# US 27/SR 1 WIDENING AND RECONSTRUCTION

EDS00-0027-00(159)(160)(174) and  
BRN-0027-03(018)  
Early, Clay, and Randolph Counties  
P.I. Nos.: 422230, 422220, 422235, 431531

Value Engineering Study Report  
90% Design Stage

September 2008

DESCRIPTION: **SHORTEN THE EAST-WEST IMPROVEMENTS TO CR-** SHEET NO.: **1 of 5**  
**267/COLOMOKEE CHURCH/ROCKMINE ROADS**

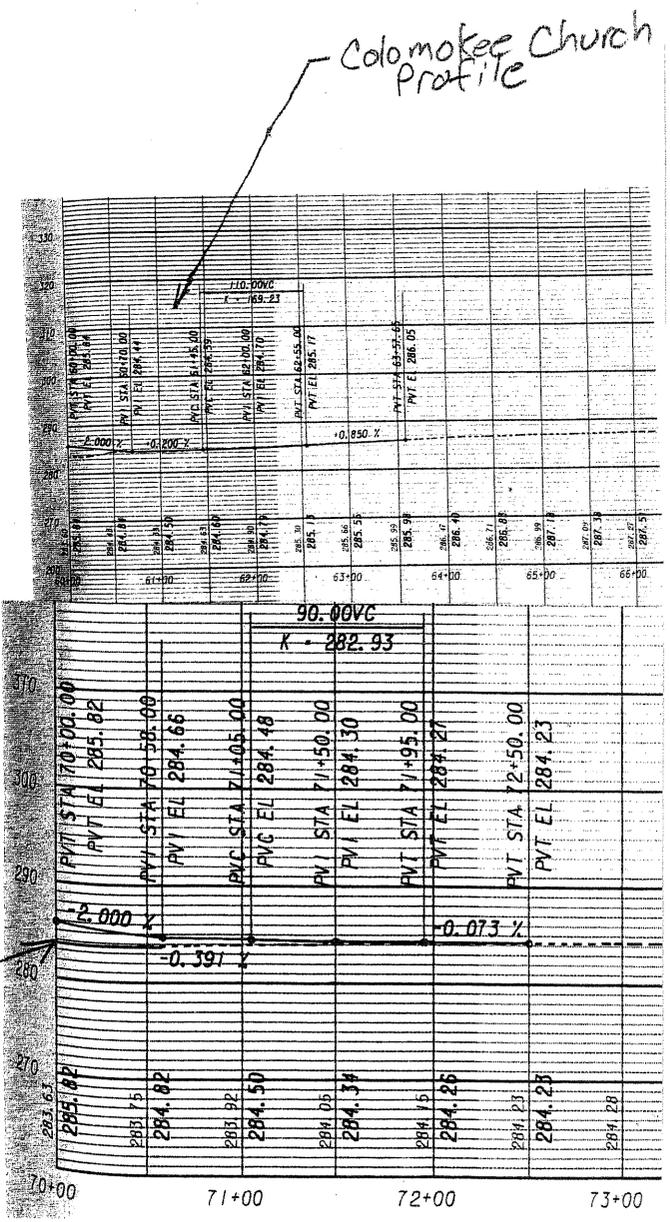
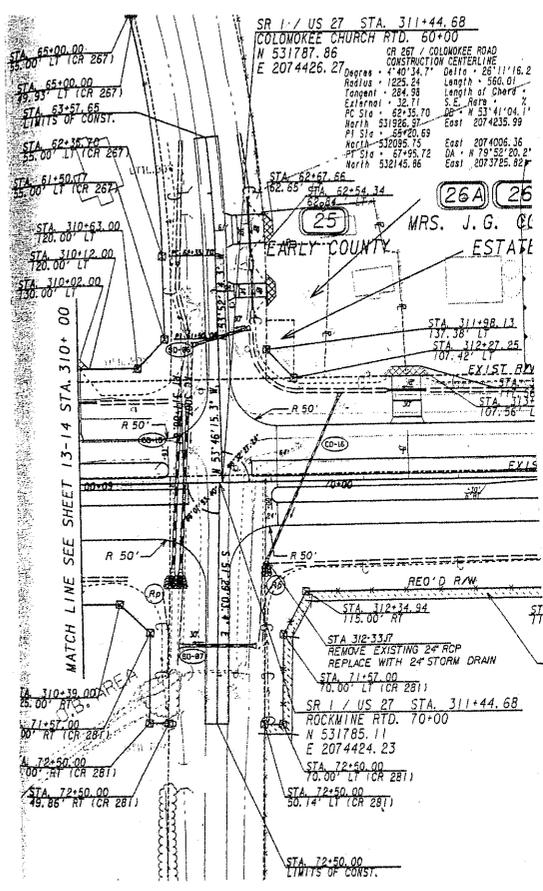
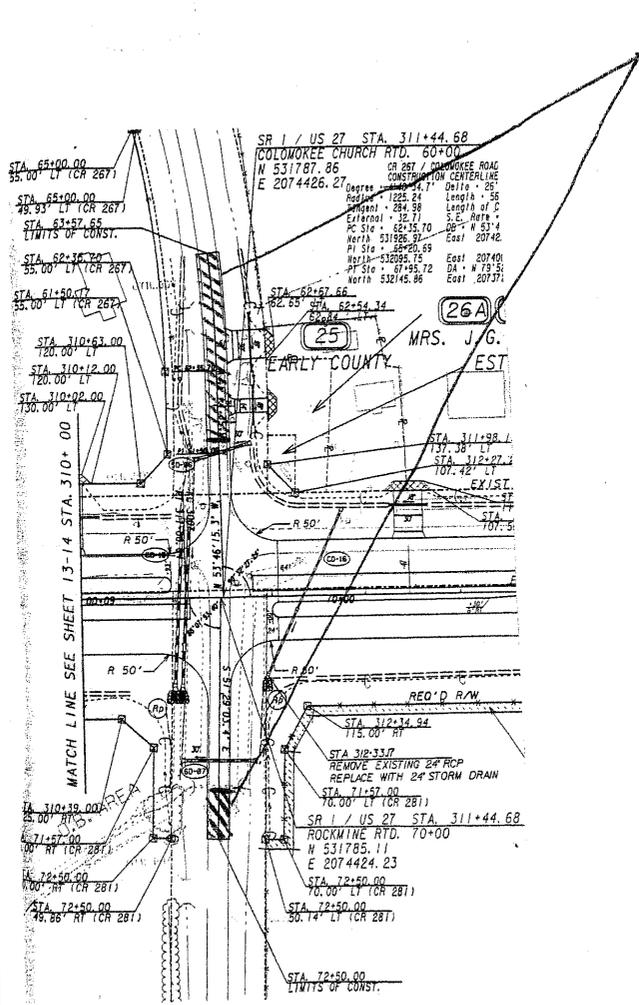
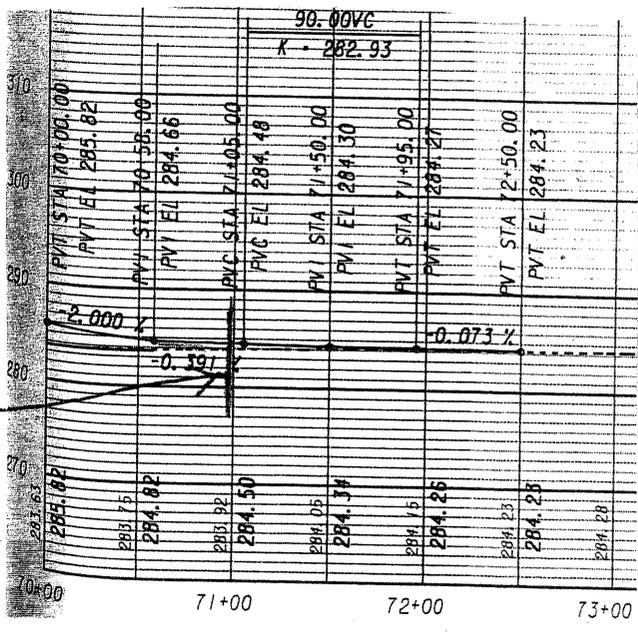
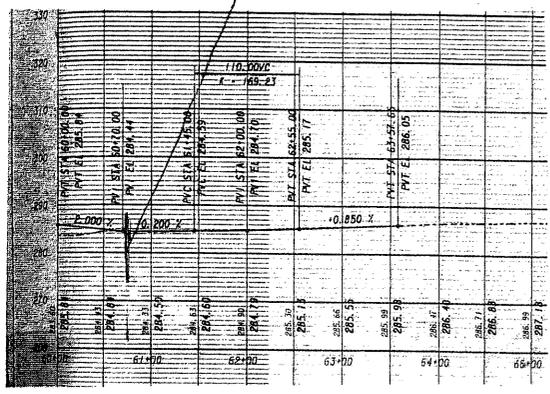
Limiting side road reconstruction reduces costs but would be required on numerous side roads to make a major impact. Due to the raising of the mainline profile grade on this project, many side roads end up needing vertical reconstruction. As such, this alternative may not have a significant impact on the project.

*Eliminate 120ft  
of Reconstruction*

*End reconstruction  
of Colomokee  
here (75ft from Q)*

*End Reconstruction  
of Rockmine  
here (100ft from Q)*
